Graven Hill Health Hub

Arboricultural Briefing Note

Document Reference: WIE16470-100-BN-10-1-2-2-ABN

An Arboricultural Impact Assessment (AIA) was submitted in April 2021 to support a Full Planning Application for a proposed Health Hub at Graven Hill. The application reference is 21/01454/F and the AIA reference is WIE16470-100-R-10-2-3-AIA.

Appendix A – Drawing 16470-AA-77-002 P03 Tree Protection & Removal Plan

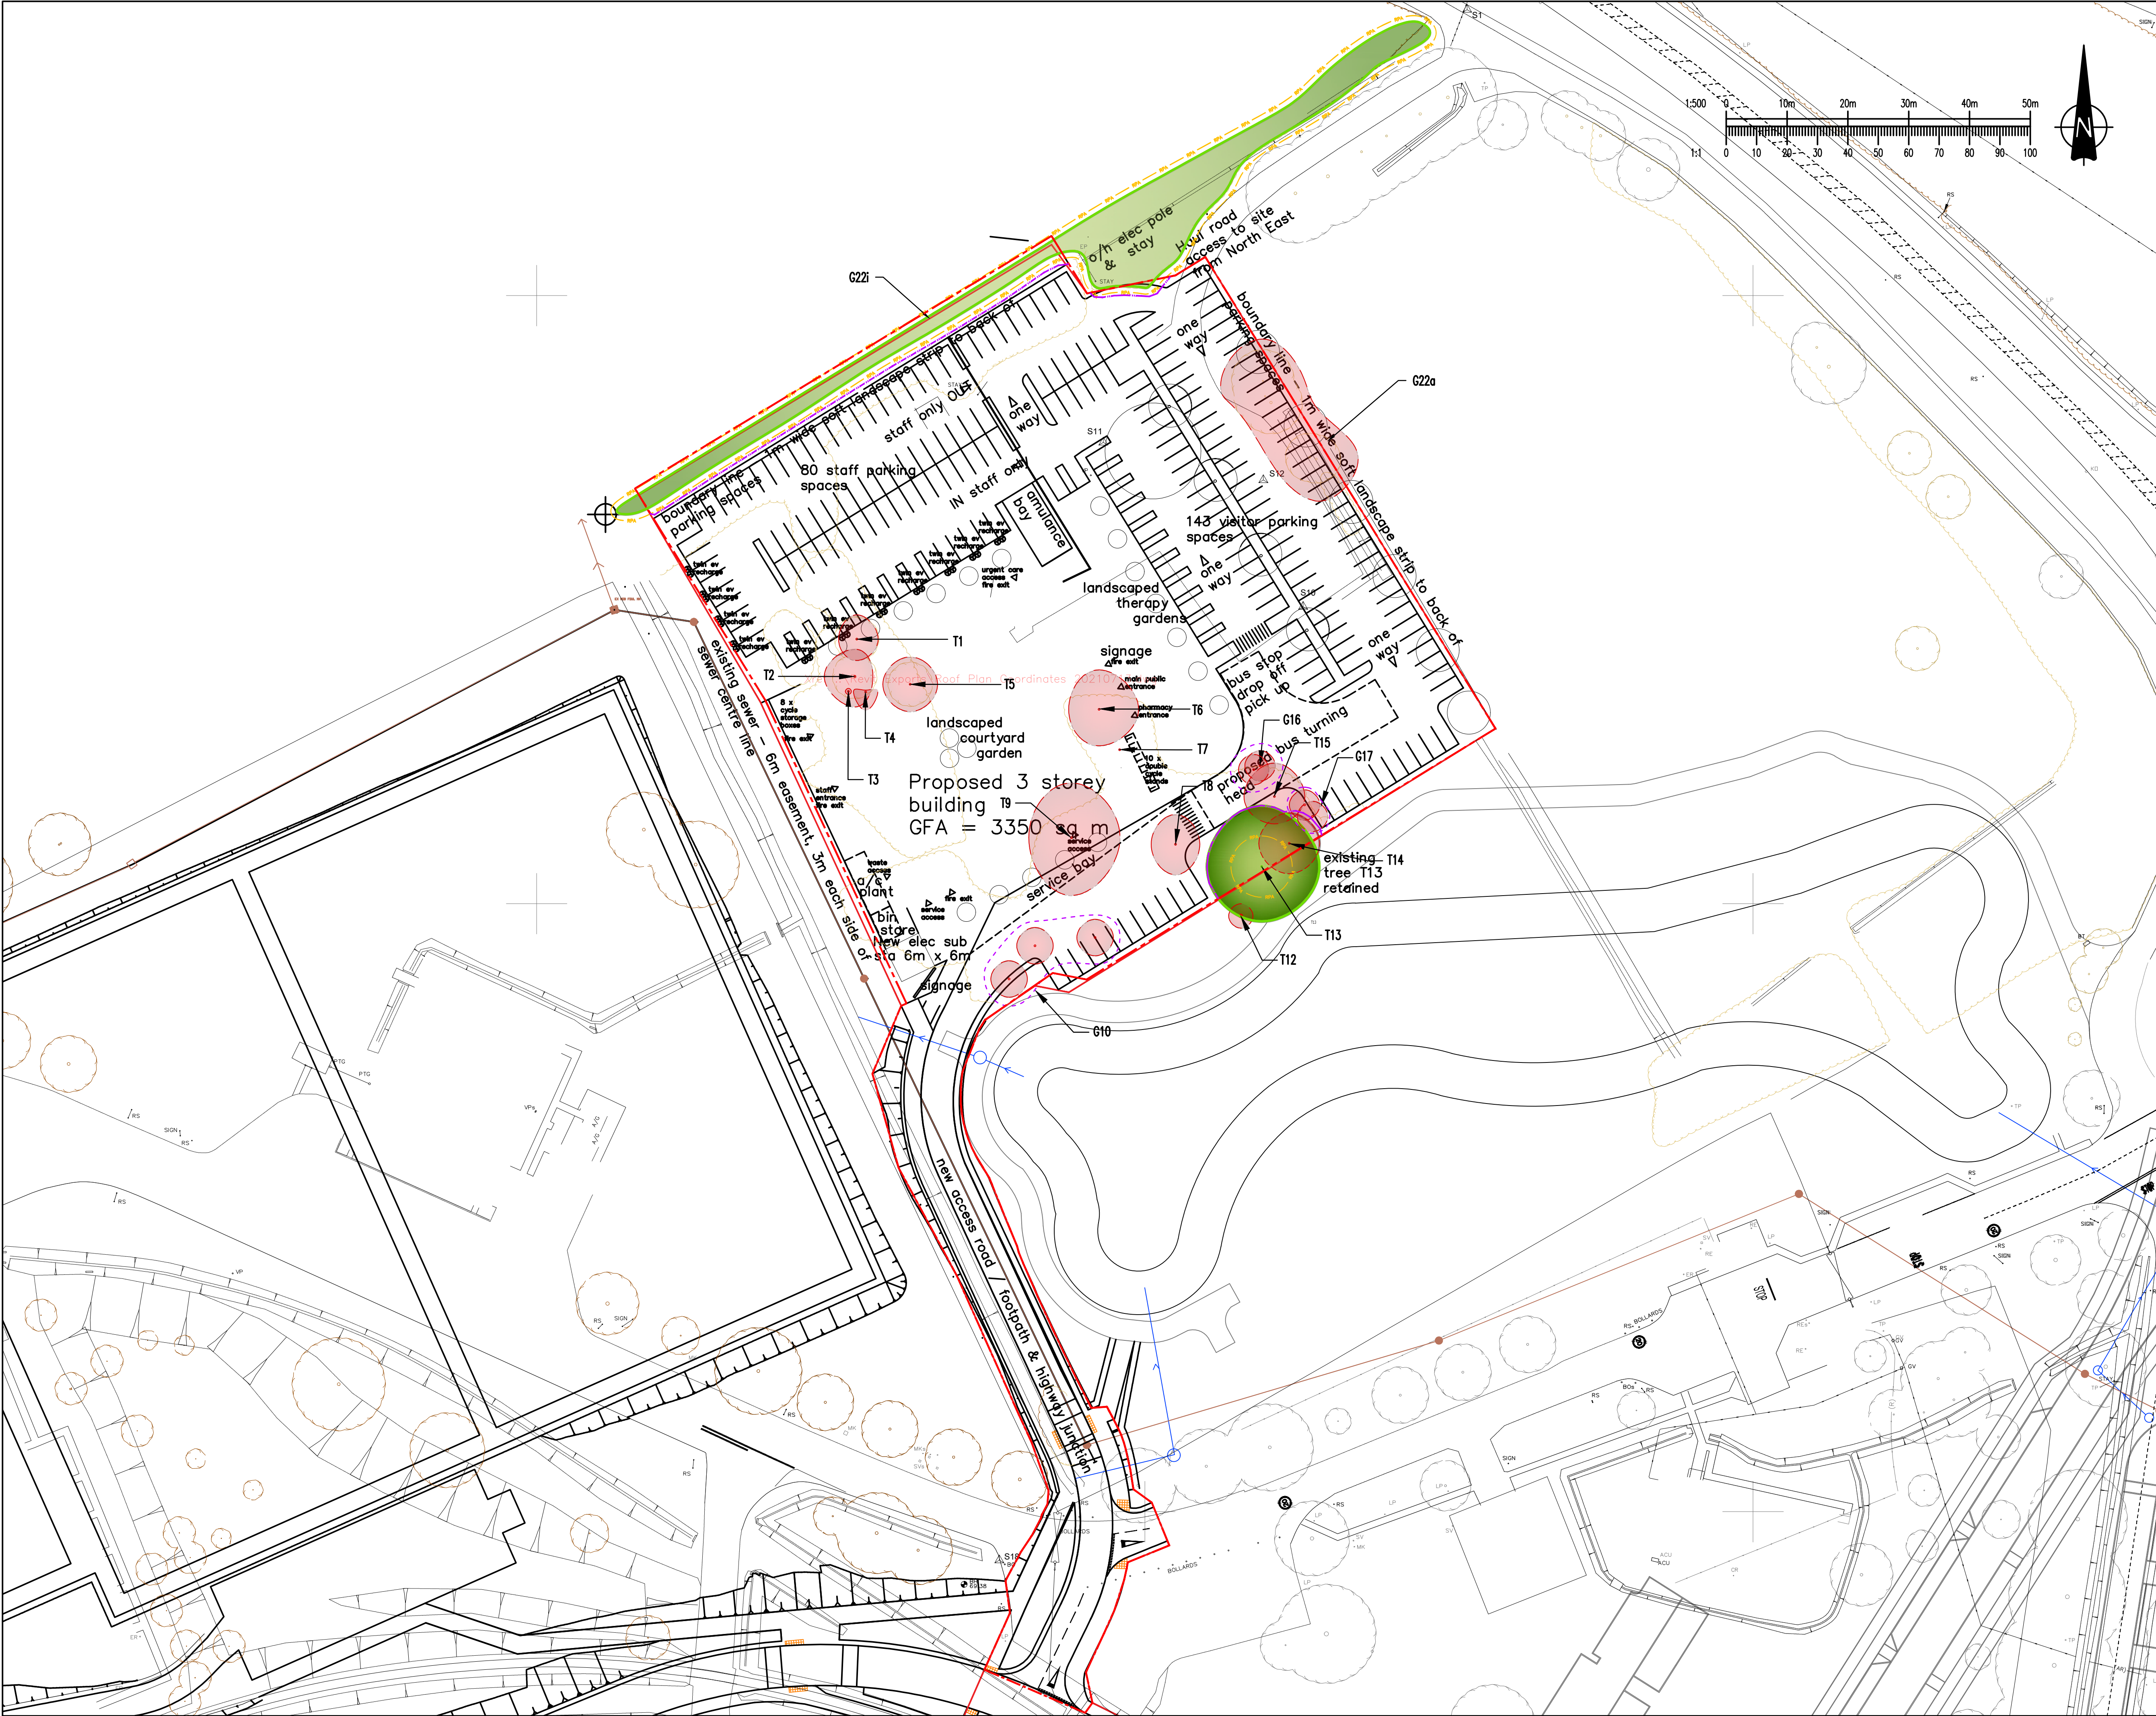
"The proposal requires the removal of 18 trees, retaining only one BS58837:2012 category B tree, and one category B group. On this subject, the submitted Arboricultural report is inconsistent, as table 2, and drawing 3 cites T14 as being removed however, AMS 11.2 and drawing 2 suggest T14 is to be retained. Confirmation is required.

In addition, further clarity is being sought on measures to protect T13 which is to be retained. This includes the following:

- Hard surfacing abuts RPA, this leaves little room for continued root development limiting the trees longevity.
- Bus turning area beneath crown spread of T13 can be expected to create above ground conflict, which a 3m crown lift is unlikely to resolve lending to most busses being taller than 3m. highway clearances are normally set at 5.2m.
- Car parking beneath T13 is inappropriate as oak drops hard fruits.

Insufficient detail covering construction of hard surfacing and working within CEZ of T13.

Further to the comments received from CDC in respect to T14, it can be confirmed that T14 is not to be retained on site. Removal of T14 can be seen on the tree removal plan shown in Appendix A of this Briefing Note. It can be confirmed that T13 is to be retained on the site only.

Further to the comments received from CDC in respect to protection of T13, the masterplan has been amended accordingly to reduce works within the area of the root protection and extent of the canopy. The amended masterplan, showing the extent of T13, can be seen in Appendix B.

Furthermore the tree retention plan, attached in Appendix A, has also been updated to include the amended masterplan. This clearly shows that the proposed works fall outside of the root protection and canopy.

The amended proposals therefore are considered to provide adequate protection for T13 as sought by CDC.
